ADDENDUM No. 1

2015 WALLA WALLA PEDESTRIAN IMPROVEMENTS PROJECT
PWE NO. ST14002
FEDERAL AID NO. TAP-9936(002)

Sheet P3, Rose Street pedestrian crossing and RRFB.

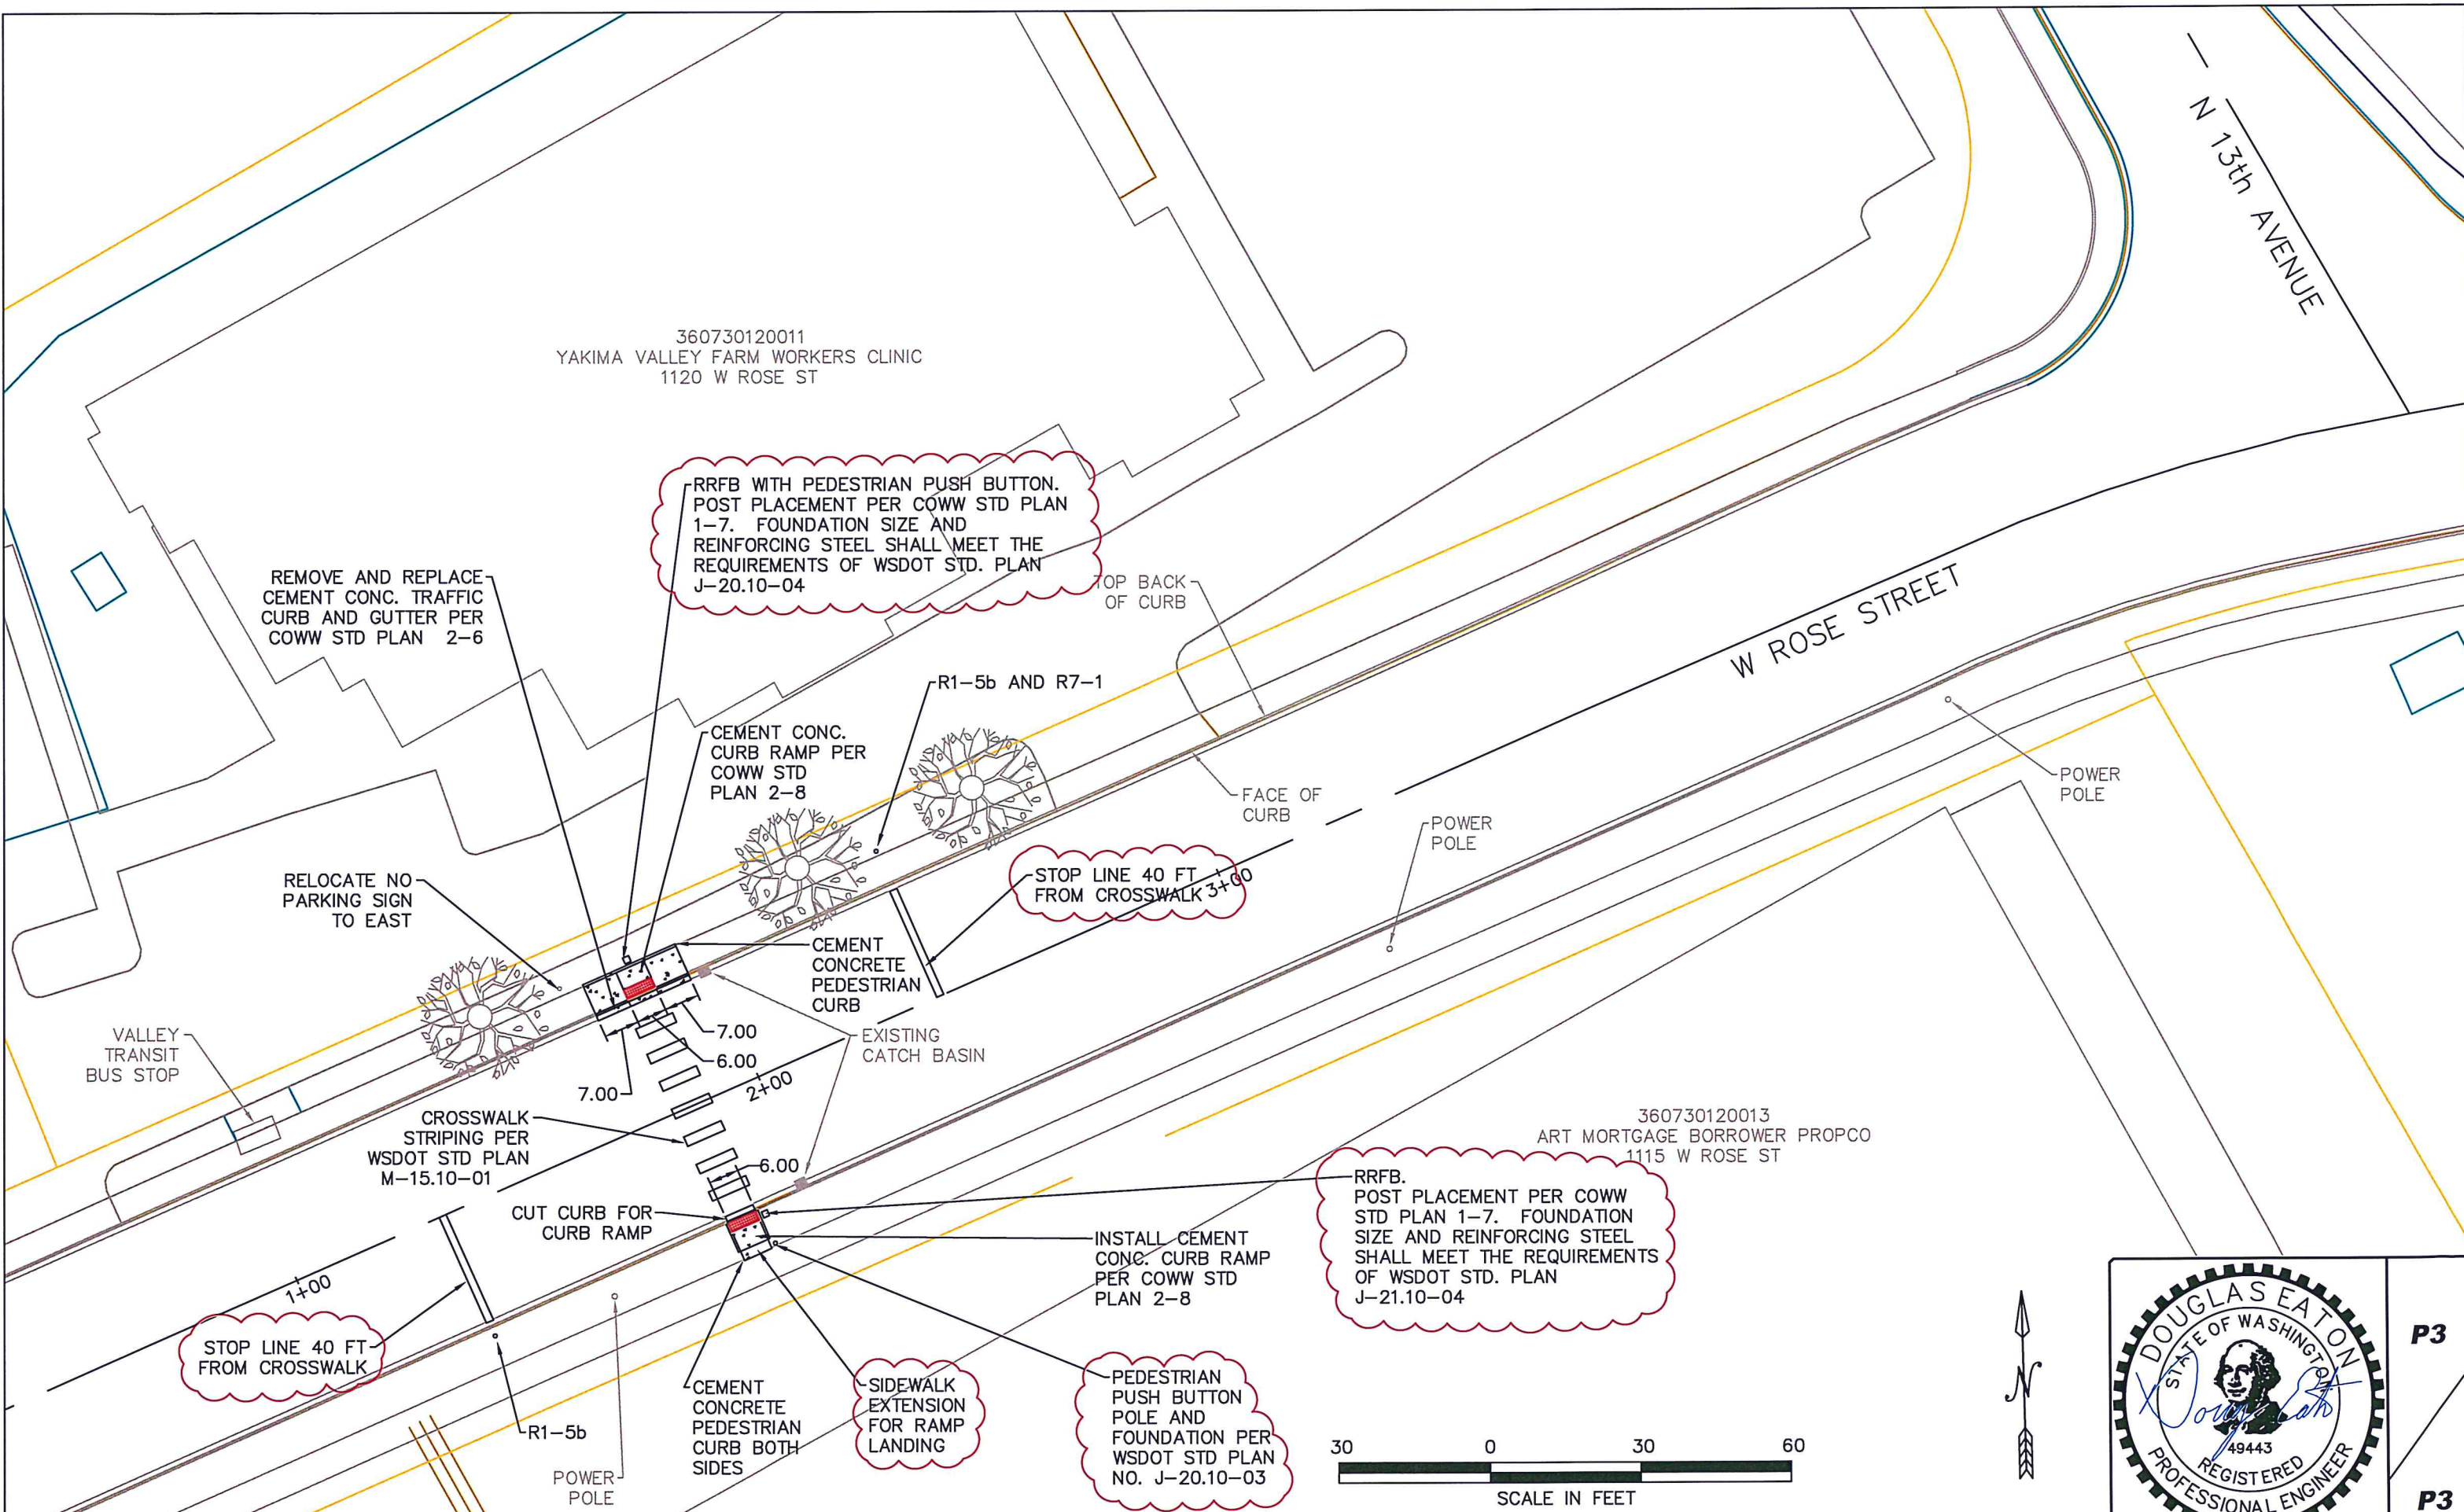
Modify notes for RRFB and Pedestrian push button pole to include WSDOT Standard Plan references for foundation size and reinforcing steel requirements.

Add note to extend landing at the top of the ramp on the south side of Rose Street.

Modify notes for stop line location distance.
